CITY AND BOROUGH OF WRANGELL, ALASKA

WOOD STREET IMPROVEMENTS PROJECT ADDENDUM TO THE PROJECT DRAWINGS

Addendum No: 2 Current Bid Opening Date: Addendum Date: April 22, 2016 April 28, 2016 at 2:00 PM

DRAWING E2.01

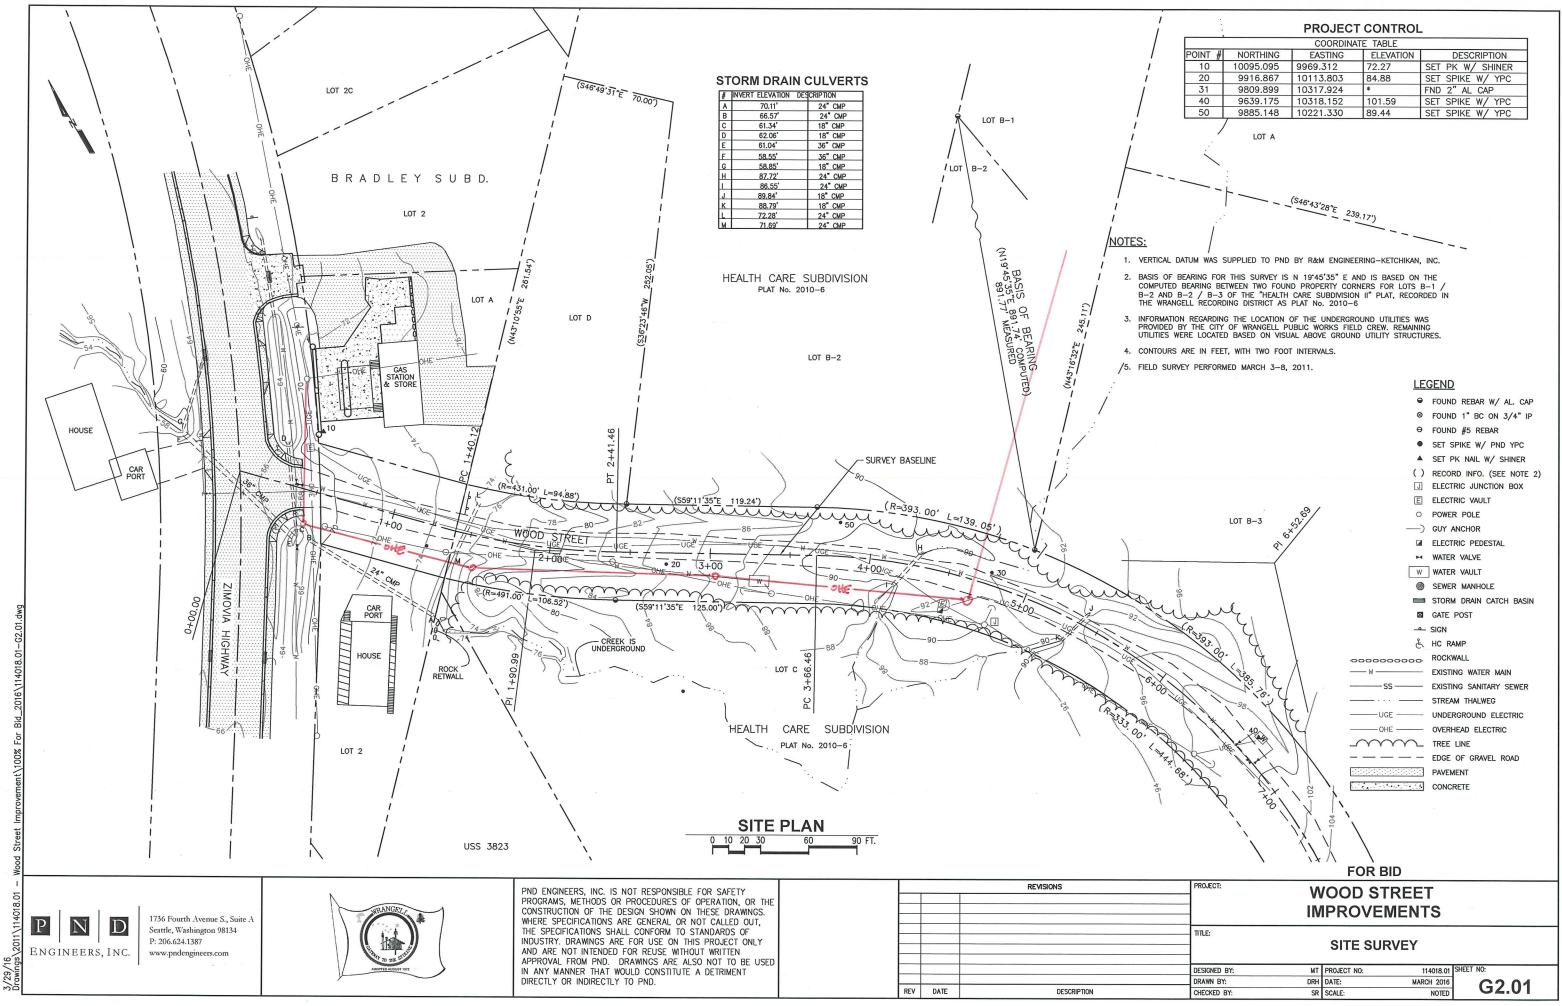
<u>Item No. 1</u> – Add existing overhead electrical poles and utility lines installed by OWNER along south side of Wood St alignment. Locations shown approximate.

<u>Item No. 2</u> – Remove all work related to underground electrical, television, telephone, and lighting along north side of Wood St alignment. Not in contract.

<u>Item No. 3</u> – Remove all work related to underground electrical and telephone to PRV vault and primary power pedestal (already installed). Not in contract.

<u>Item No. 4</u> – Add work related to electrical connection from existing pole to relocated PRV vault.

<u>Item No. 5</u> – Add work related to 2" conduit (no conductors) crossing road with capped end installed beyond sidewalk but within Wood St ROW.

DRAWING E2.02

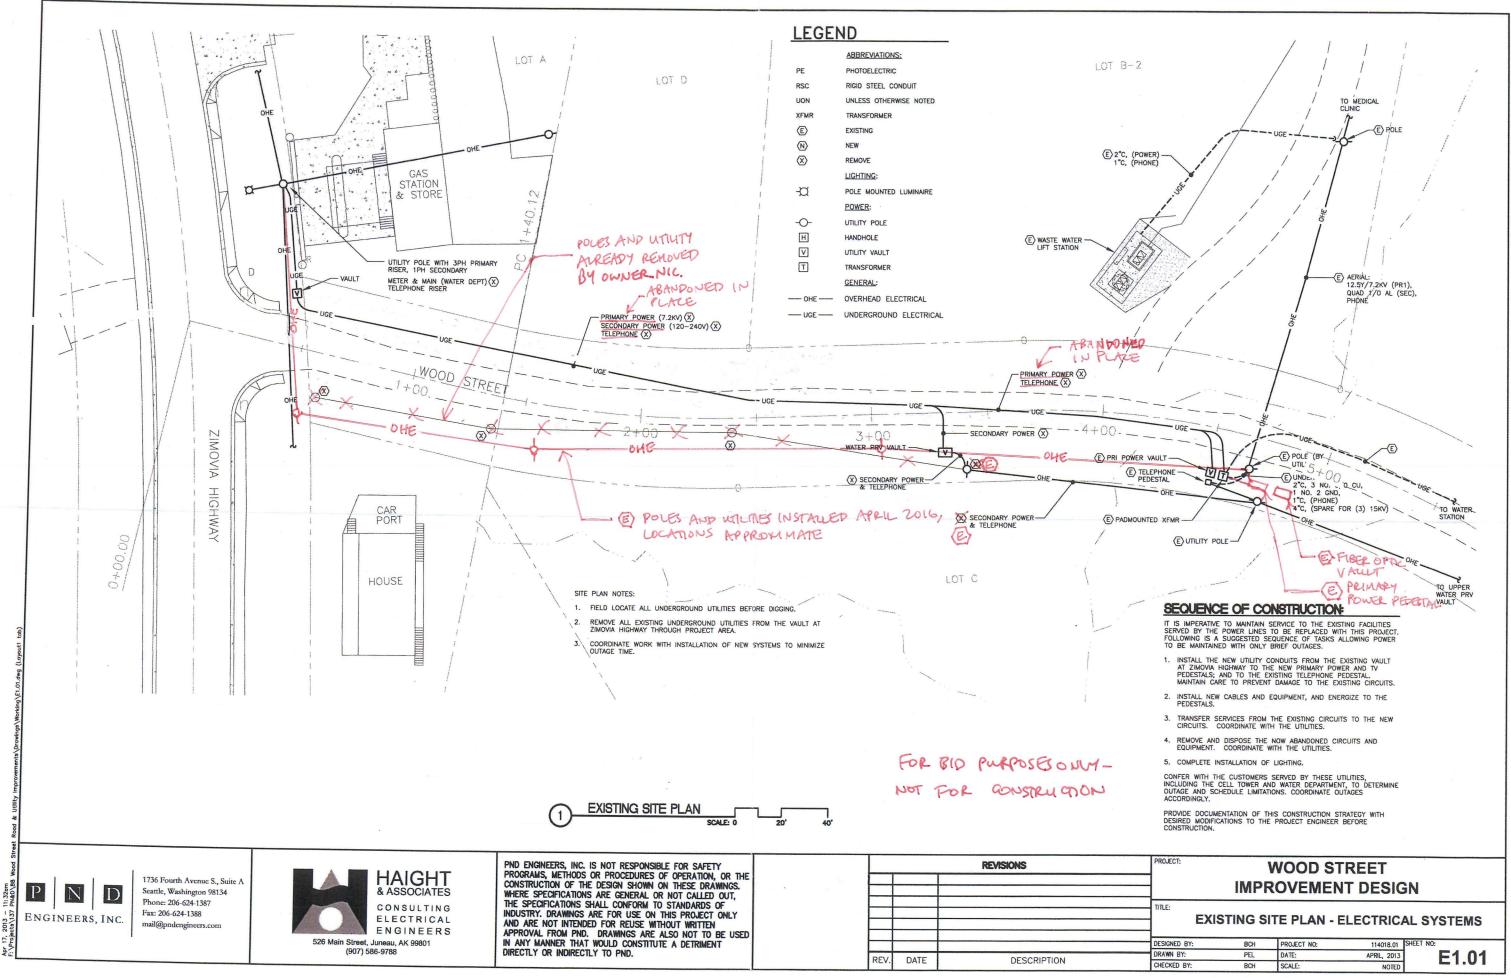
<u>Item No. 1</u> – Remove unused Detail 3 – Handhole

<u>Item No. 2</u> – Remove unused Detail 2 – Underground Roadway Crossing

<u>Item No. 3</u> – Remove unused Detail 5 – Primary Junction Cabinet

<u>Item No. 4</u> – Remove unused Section 1 – Sidewalk
